TAL-CO SUPPLEMENTAL INSTRUCTION #78			
LIGHTING AT MAIN WASHROOMS #05 & #06			
Project Name:	RW TOMLINSON - NEW HEAD OFFICE		
Project Location:	100 CitiGate Drive, Ottawa, Ontario		
ARCH. SI #:	ASK 221	Issued By:	Farah Bano
STRUC. SI #:	N/A	Date Issued:	January 2, 2018
MECH. SI #:	N/A	Revision #:	N/A
ELEC. SI #:	N/A	Revision Date:	N/A

TITLE: LIGHTING AT MAIN WASHROOMS #05 & #06

DRAWING TITLE:
**MAIN BATHROOM CEILING PLAN
FLOORS 2-4**

DRAWING No:
ASK-221

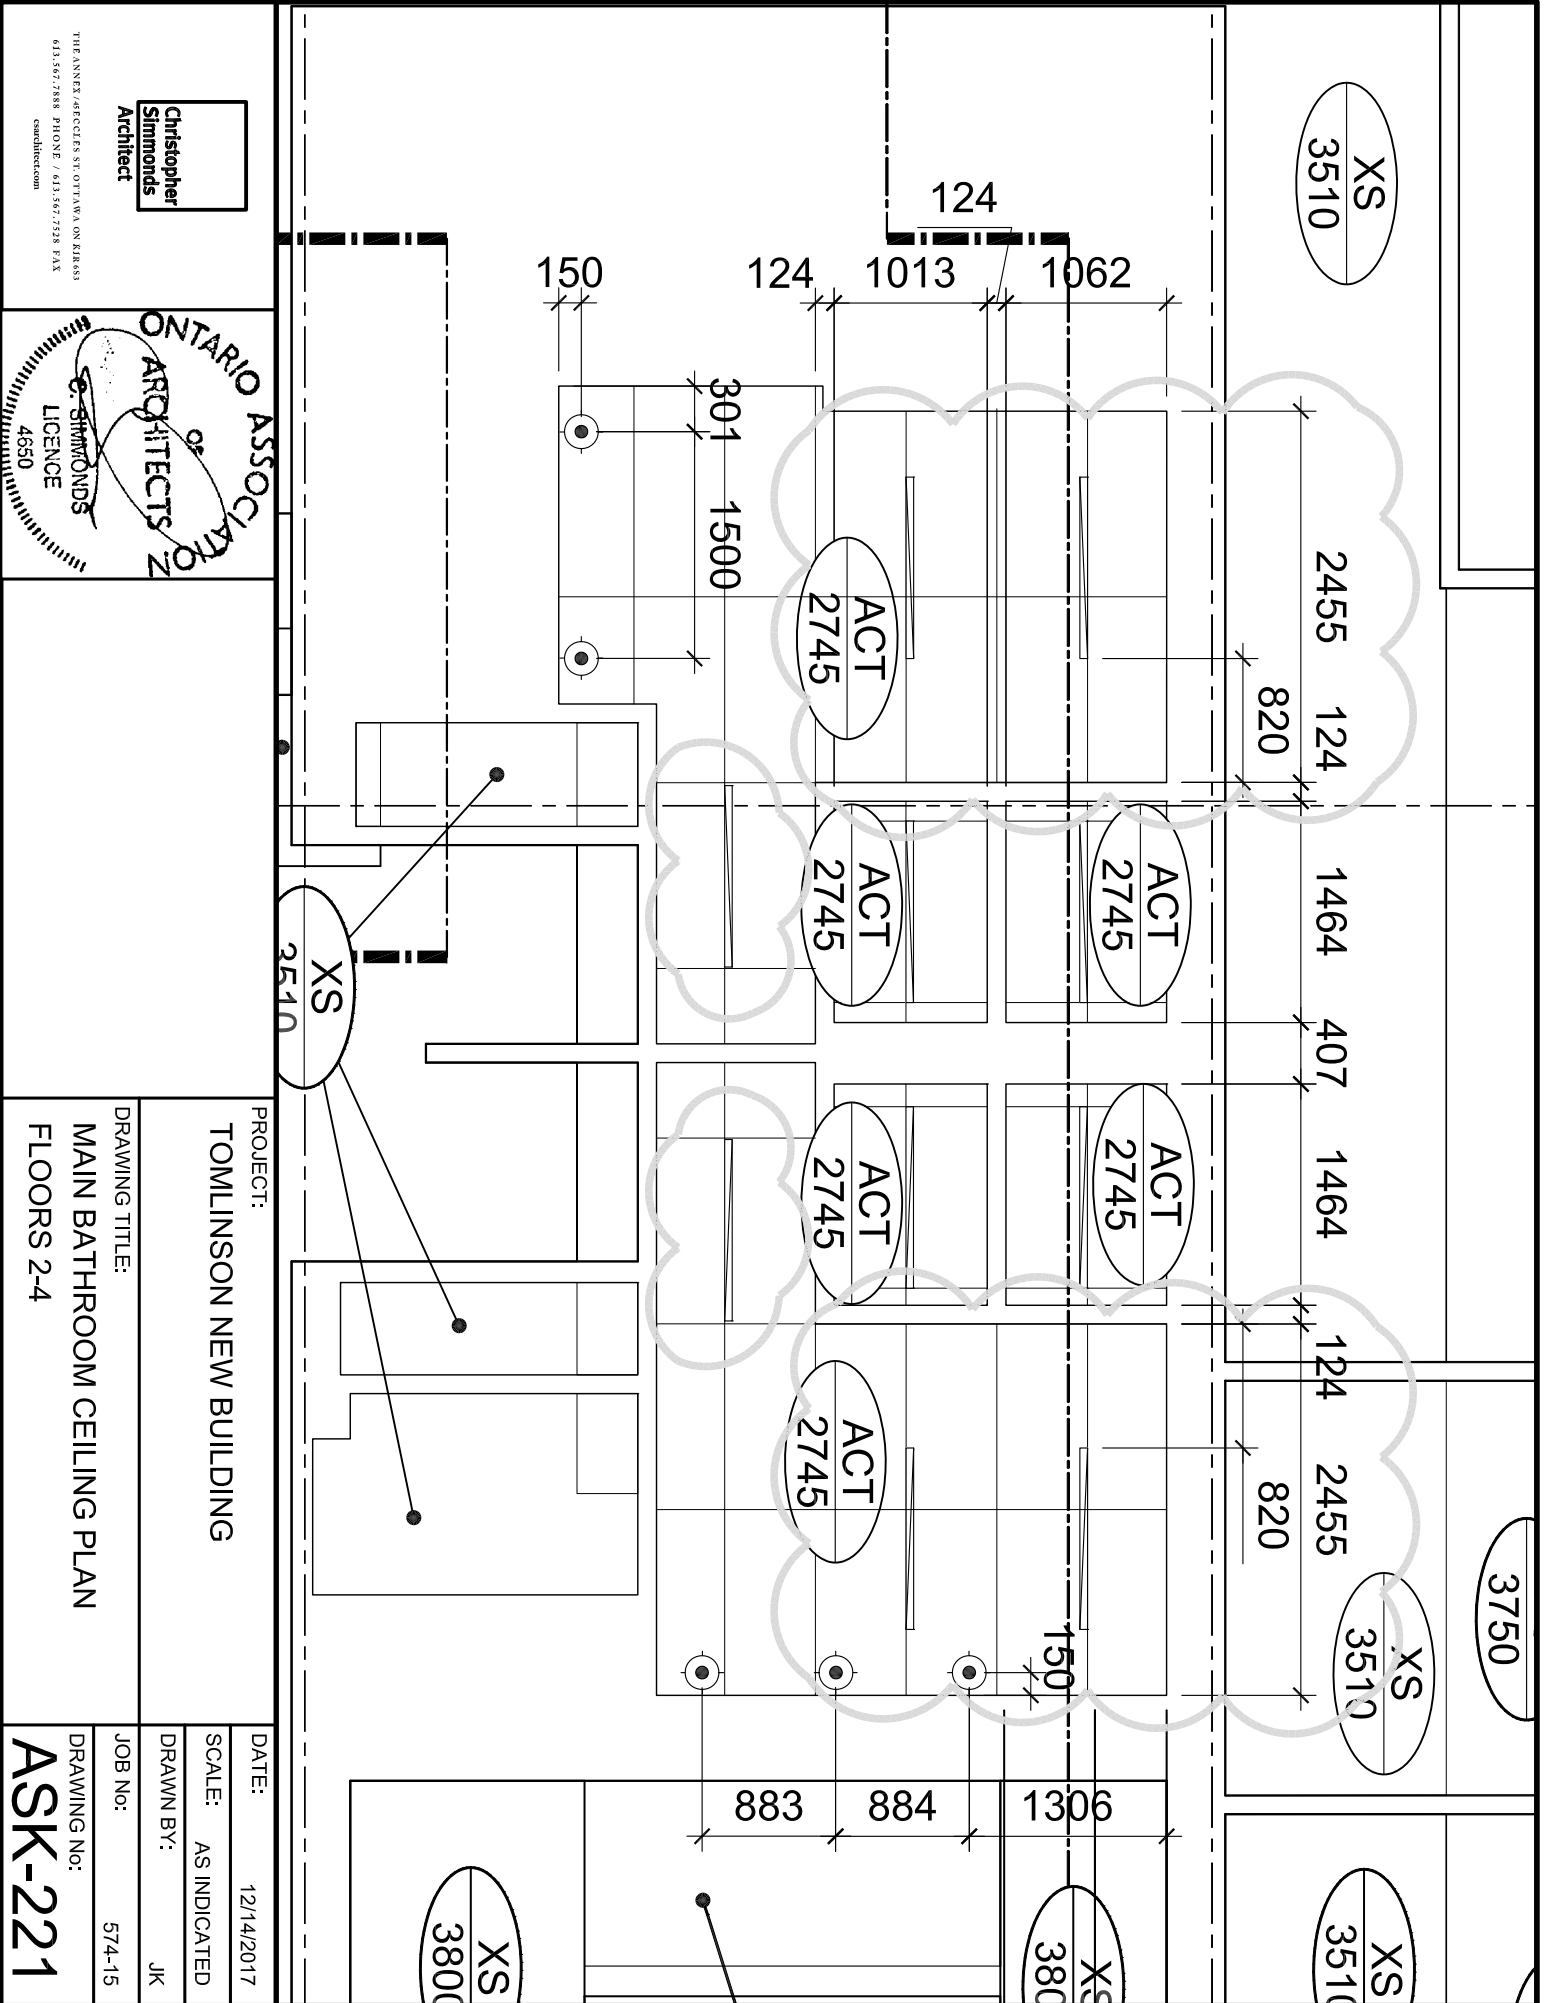
Reposition lights in main washrooms on Floors 2, 3 & 4 as per attached ASK 221. Ground Floor main washroom lighting will be recessed, therefore no change is required there. Height of suspended lights: 2550AFF.

T-Bar ceiling tile layout revised for simplicity.

To avoid potential conflict between suspended lights, and owner requested 9ft washroom partition doors.
